CORRIGENDA / ADDENDUM-04

SUBJECT: TENDER ENQUIRY FOR RATE CONTRACT OF DISTRIBUTION BOARDS AS PER TECHNICAL SPECIFICATION NO. PE-RC-999-558-E005(REV-0)

**AMENDMENT TO TECHNICAL SPECIFICATION FOR DISTRIBUTION BOARDS
FOR RATE CONTRACT**

SPECIFICATION NO.: PE-RC-999-558-E005
AMENDMENT NO # 1
REV. NO. 00 DATE: 07/03/2020
Page 1 of 2

Typical Single line diagram for Lighting panel

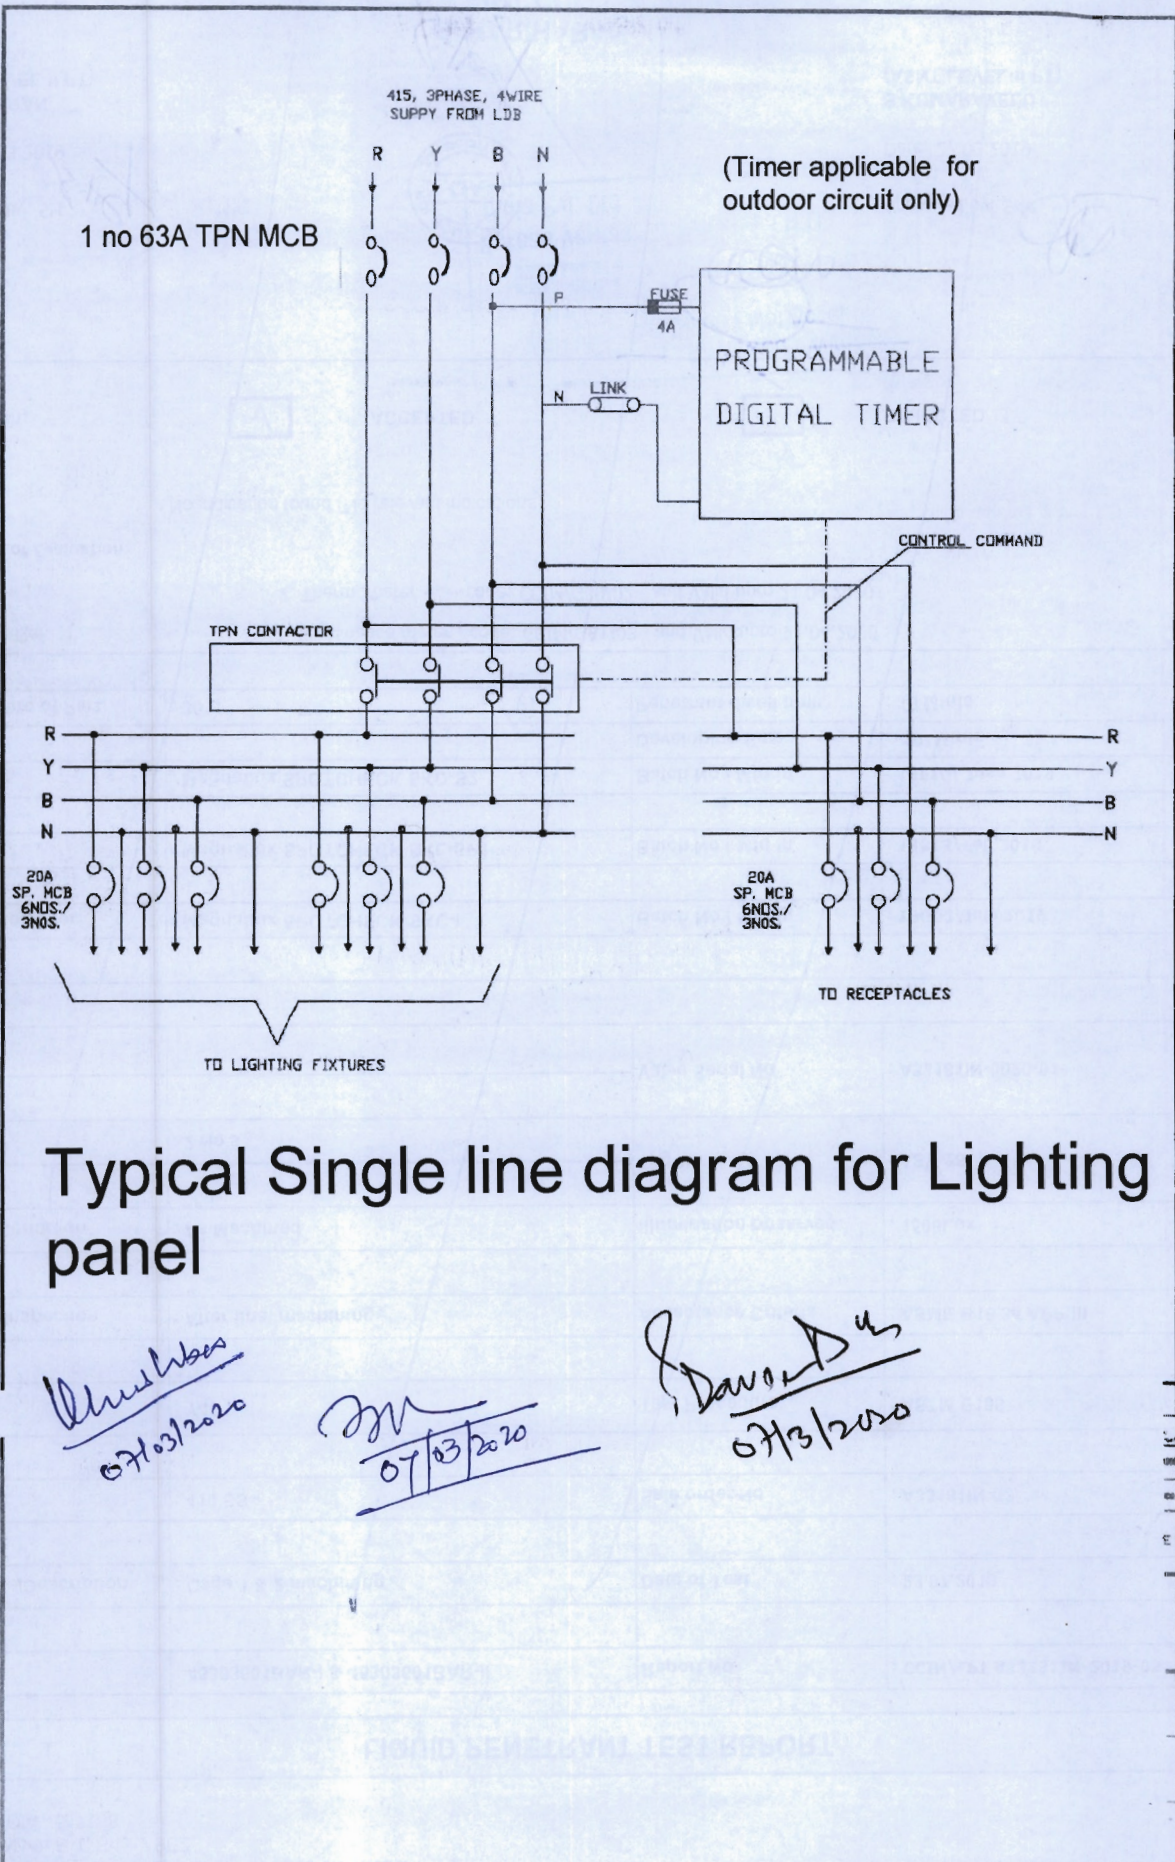
1	BOQ, Sr. No. 1.3a: As per DATA Sheet-A Under Voltage relay is not mentioned whereas in Technical specification it is asked, please clarify if it is required or not.	Bidder to refer clause no 1.3 of Section-I, Page – 3 of 20 : "The stipulations of Section-I, followed by those of Data Sheet-A shall prevail and govern in case of conflict between the corresponding requirements of Section-I and Section-II." Bidder to provide undervoltage relay as per spec..
2	BOQ, Sr. No. 2.1 LPs: As per data sheet –A, Point 4.11, Timer & Photocell both are marked for consideration, while in specific technical requirement, Clause no. 3.2.1 Points (G) only a programmable time switch (Astro type) is to be considered. Please clarify on Time switch /Photo cell requirement.	Datasheet-A clause no 4.11 indicates the requirement of timer and photocell both. Specific technical requirement clause no 3.2.1 (g) contains details of the timer. Bidder to follow spec. Diagram of timer circuit is enclosed with corrigenda (applicable for outdoor circuit only).
